POWER_ON multiple true fix & simplification v100

The D2.2 state POWER_ON for the Type 3 and Type 4 PSE state diagram contains a number of permutations that would cause multiple arcs to be true simultaneously. This baseline fixes those, as well as introducing a compound error variable to simplify the logic. Also, the statement pse_ss_mode_update is added to the POWER_ON state. This statement was forgotten to include in D2.2 when implementing [yseboodt_07_1116_2p4p.pdf](#)

Modify Figure 33–15 on page 95 as follows:

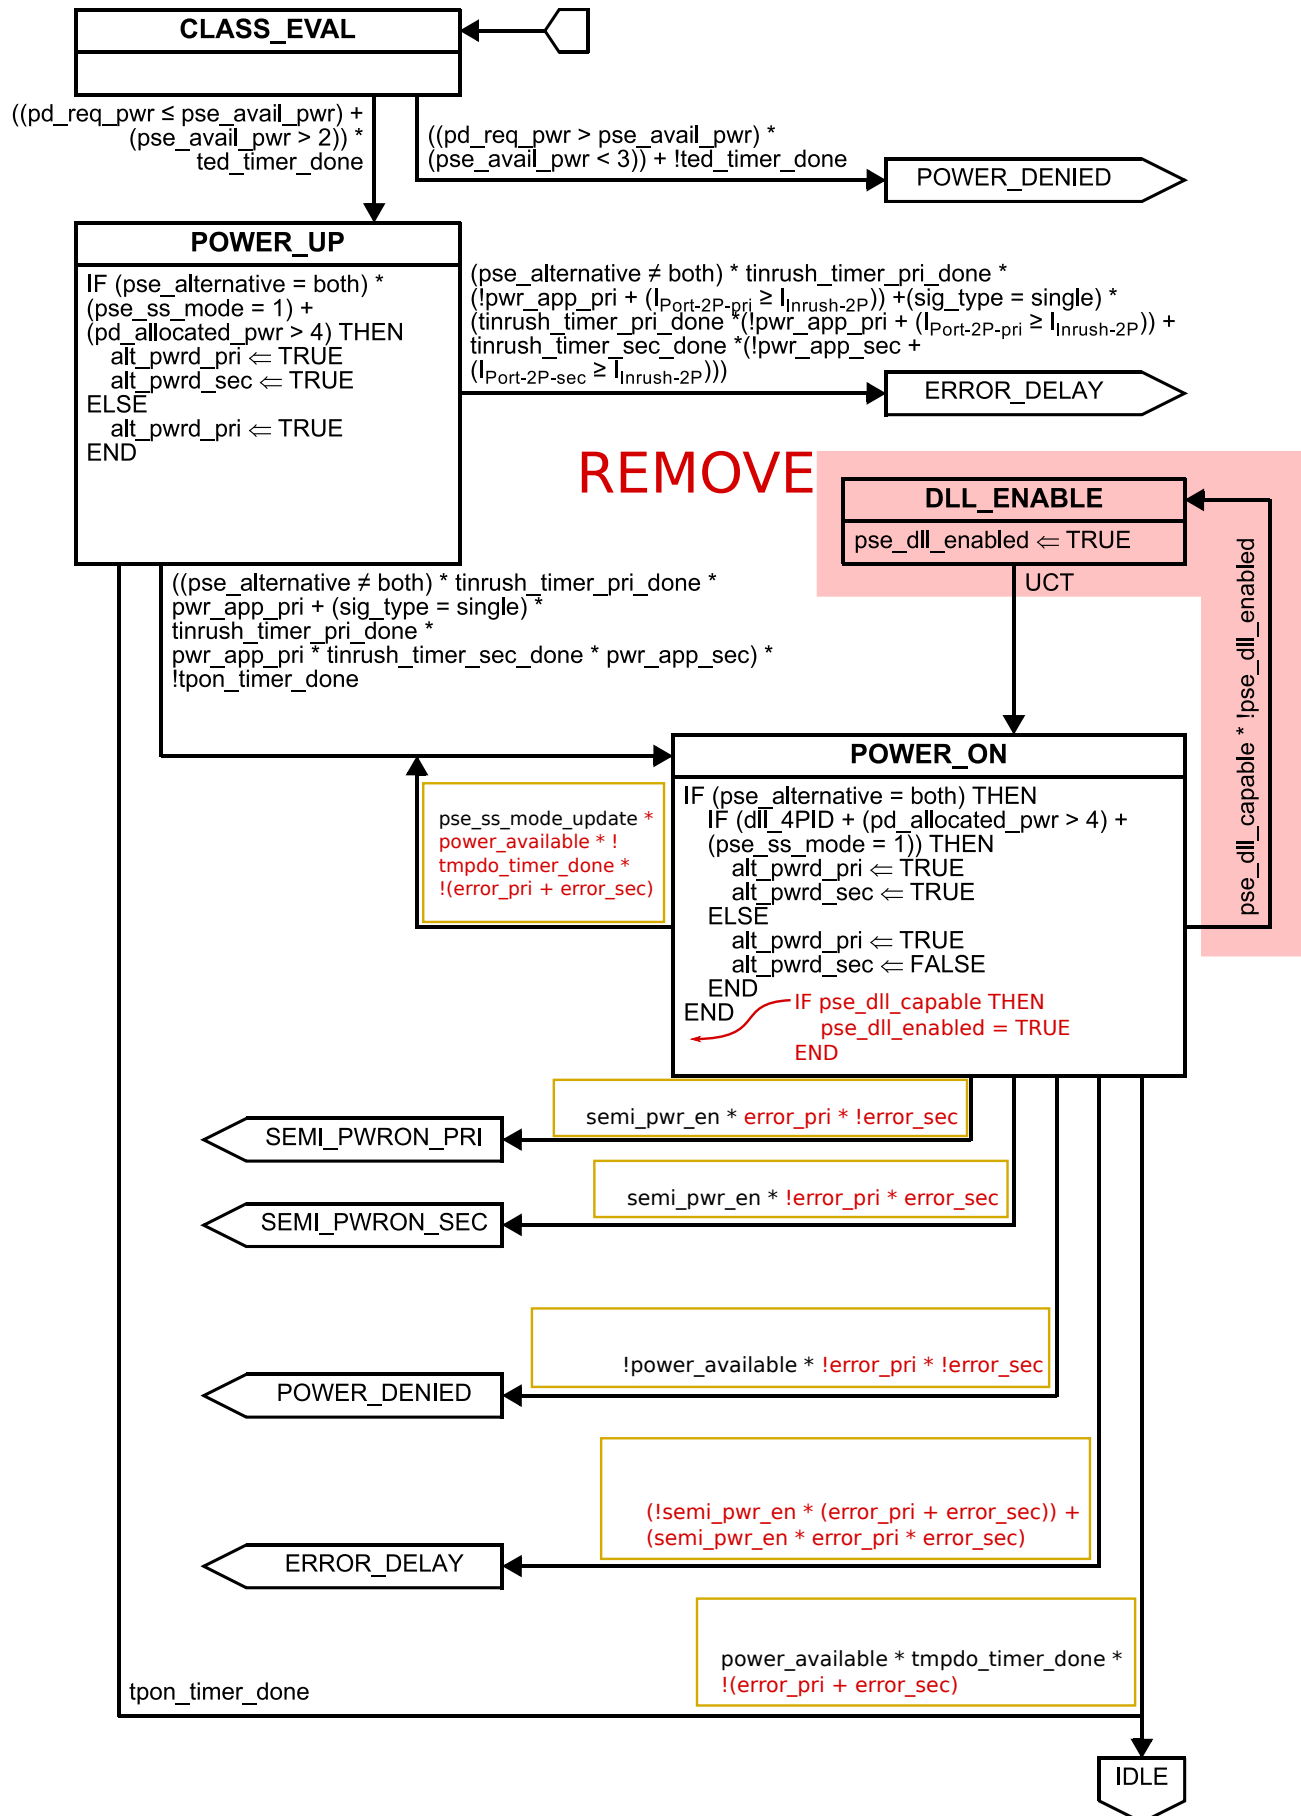
For reference, the original D2.2 POWER_ON state:

Insert new variables as follows:

error_pri

A variable indicating if either a short-circuit or an overload is detected on the Primary Alternative, or if the voltage on the Primary Alternative is outside of the operating range. This variable is set according to logical result of “short_det_pri + ovld_det_pri + option_vport_lim_pri”.

error_sec

A variable indicating if either a short-circuit or an overload is detected on the Secondary Alternative, or if the voltage on the Primary Alternative is outside of the operating range. This variable is set according to logical result of “short_det_sec + ovld_det_sec + option_vport_lim_sec”.
